ENTERPRISE SUBDIVISION

Engineering Comments: FINAL PLAT COMMENTS (should be addressed prior to submitting the FINAL PLAT for review and/or signature by the City Engineer):

APPLICATION NUMBER 3 DATE June 1, 2017

DETAIL SITE PLAN

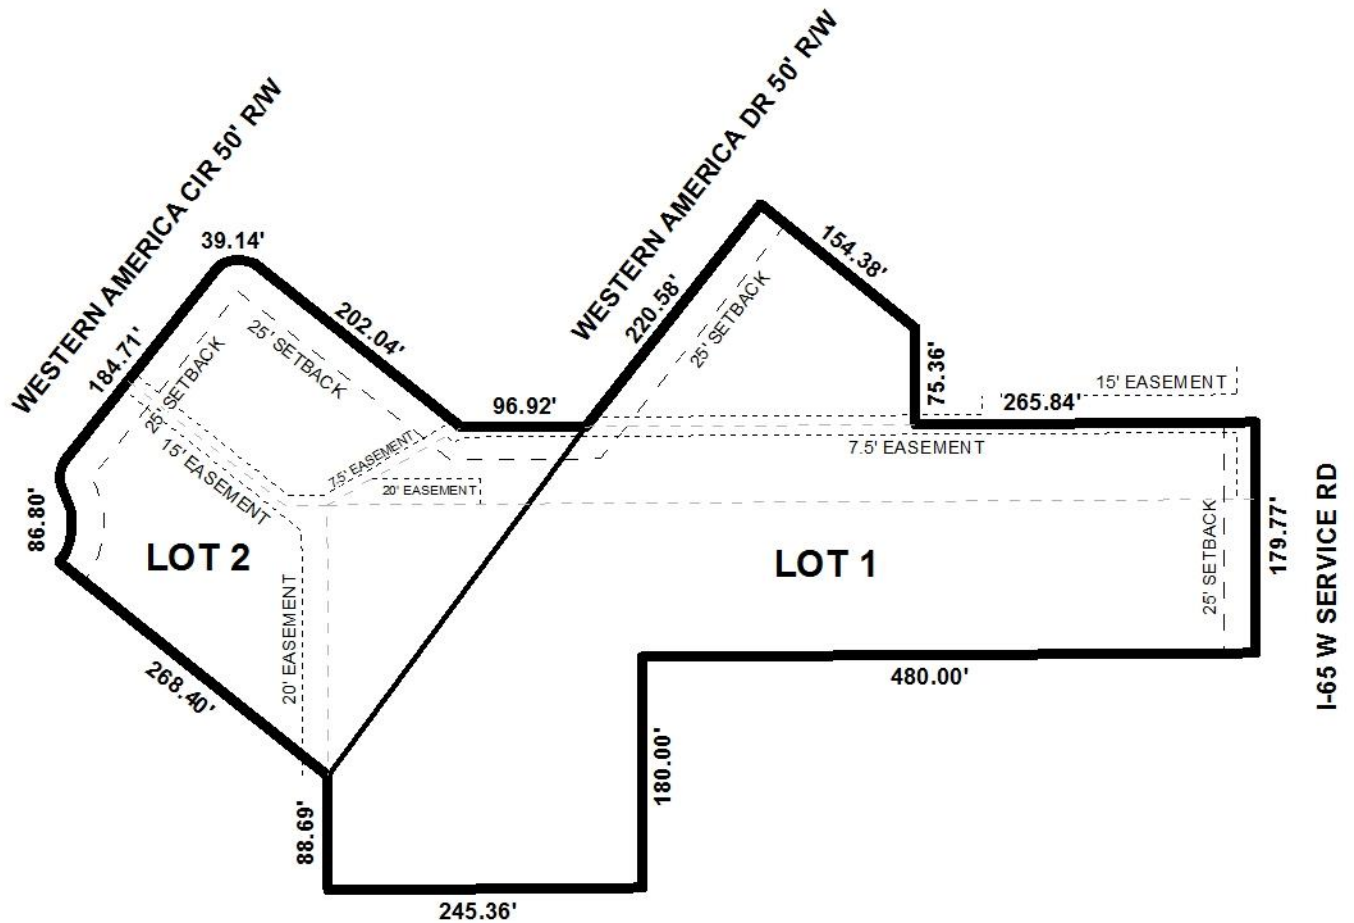
Proposed Lot 1 is irregularly shaped, with 179.77'± of frontage on West I-65 Service Road South, to the East, an ALDOT-maintained limited access route with a 300' right-of-way width; and 220.58'± of frontage on Western America Drive, to the West, a minor street with curb and gutter requiring a 50' right-of-way width. Proposed Lot 2 is also irregularly shaped with 318.53'± of frontage along Western America Drive, and 291.08'± along Western America Circle, a closed-end minor street with curb and gutter also requiring a 50' right-of-way width. Adequate rights-of-way are illustrated along all streets to which the proposed lots have frontage; therefore, no additional dedications should be required.

It should be noted that the widths of the portions of proposed Lot 1 along which it has frontages are large enough to be potentially re-subdivided and, in accordance with Section V.D.3. of the Subdivision Regulations, are not exclusive of unusable land thus contributing to a depth more than 3.5 times its widths at its potential building setbacks. Such a design may also be regarded as a "panhandle" lot, which is generally discouraged by Section V.D.1. of the Subdivision Regulations; the exception being the approval of lots located where varied and irregularly-shaped lot designs are common, and the informality of design is consistent with other lots in the vicinity. Planning Commission approval of various irregularly shaped lots within the immediate vicinity of the subject site may facilitate approval of this request, but will require waivers of Sections V.D.1. and V.D.3. of the Subdivision Regulations. Also, if approved, a note should be required on the Final Plat stating further re-subdivision of the Lot 1 will not be allowed until additional public street frontage is provided.

Regarding access management, proposed Lot 1 should be limited to one curb cut to Western America Drive and one curb cut to West I-65 Service Road South; and proposed Lot 2 should be limited to one curb cut to Western America Drive, and one curb cut to Western America Circle.

Multiple easements are illustrated on the preliminary plat, including: 15' and 7.5' drainage easements in the Northwest and Northeast of proposed Lot 1, respectively; a 15' utility easement along a portion of West I-65 Service Road to which Lot 1 has frontage; and 7.5', 20' and 15' drainage and utility easements in the North, East, South, and West of proposed Lot 2, respectively. As such, if approved, a note should be required on the Final Plat stating no structures shall be constructed in any easement.

- 1) submit a revised preliminary plat to include the remainder of the parcel from which Lot 1 is proposed to be subdivided, including additional fees and mailing labels.
